**FINAL
ENVIRONMENTAL IMPACT REPORT**

**CORRAL DE TIERRA NEIGHBORHOOD RETAIL VILLAGE
COUNTY OF MONTEREY, CALIFORNIA**

**COUNTY OF MONTEREY
RESOURCE MANAGEMENT AGENCY**

November 2010

AAA-41

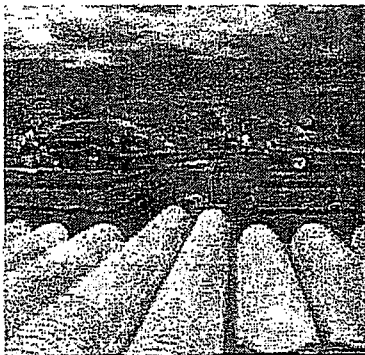
The EIR claims that the recharge facility would be "stormtech chambers." Is this a reference to the product of a company called Stormtech?

In different places, the EIR calls the facilities "storm tech chambers," without capitalization. What is a storm tech chamber? Is it anything other than a product manufactured by the company called Stormtech?

AAA-41

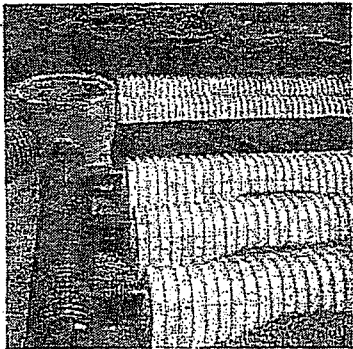
This graphic shows a cutaway of a parking lot on top of a Stormtech facility, apparently as proposed by the applicant here. The Stormtech facility is largely composed of pipes. The pipes would be underground, and would not be accessible. The function and operations of the pipes could not be visual monitored. There is no way to measure any recharge to the aquifer from the pipes.

The underground Stormtech pipes are set in gravel, as this graphic shows. This is further evidence why the amount of recharge, if any, cannot be accessed, measured, or monitored.

Attachment 1: Pine trees being cut down at Project site
Eucalyptus trees being cut down at Project site.

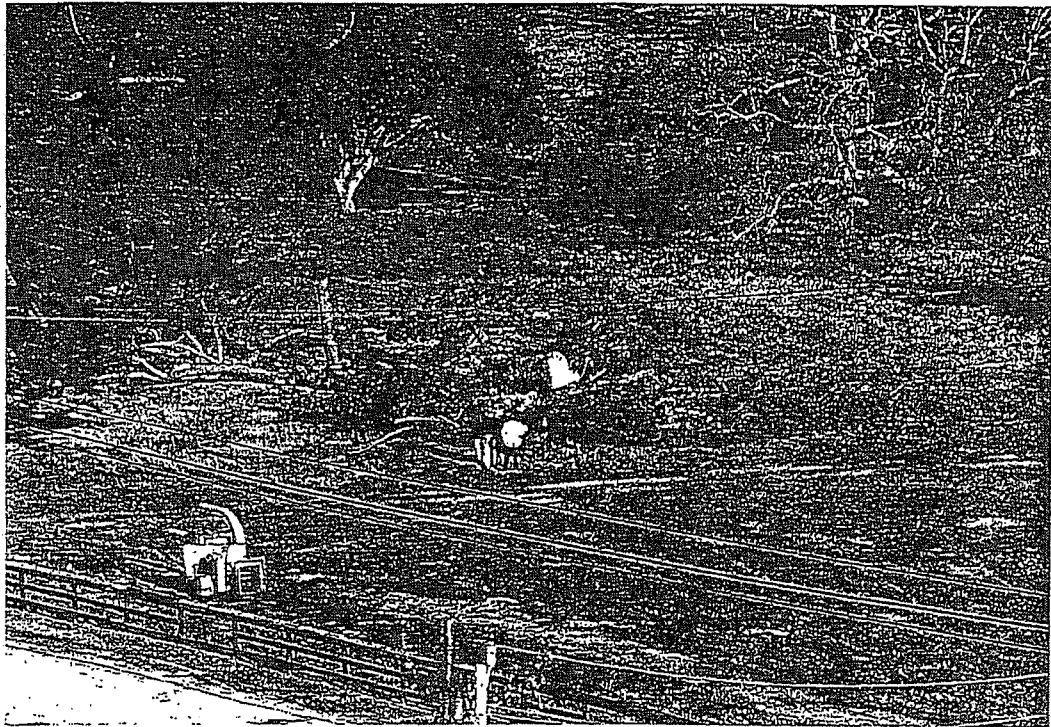
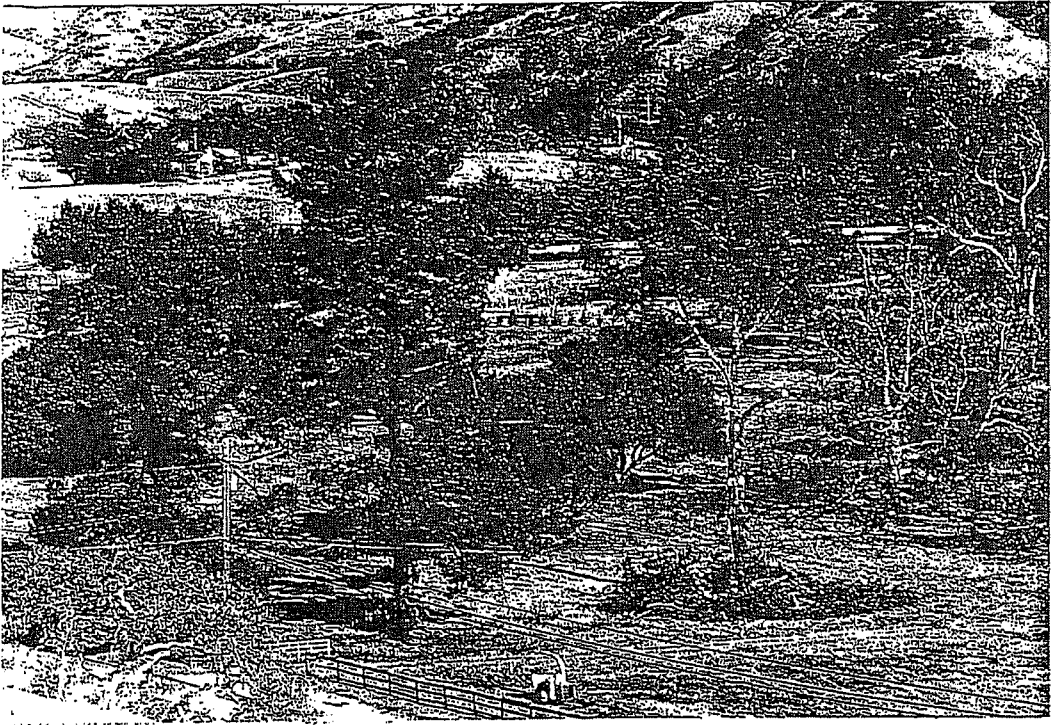
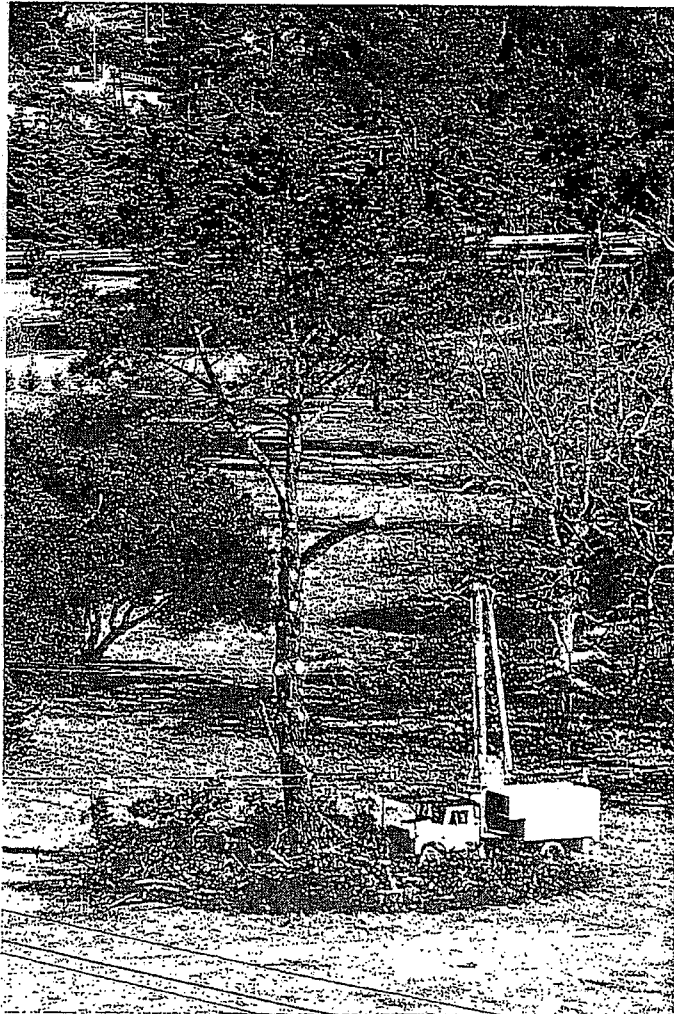
↑
EEE-7
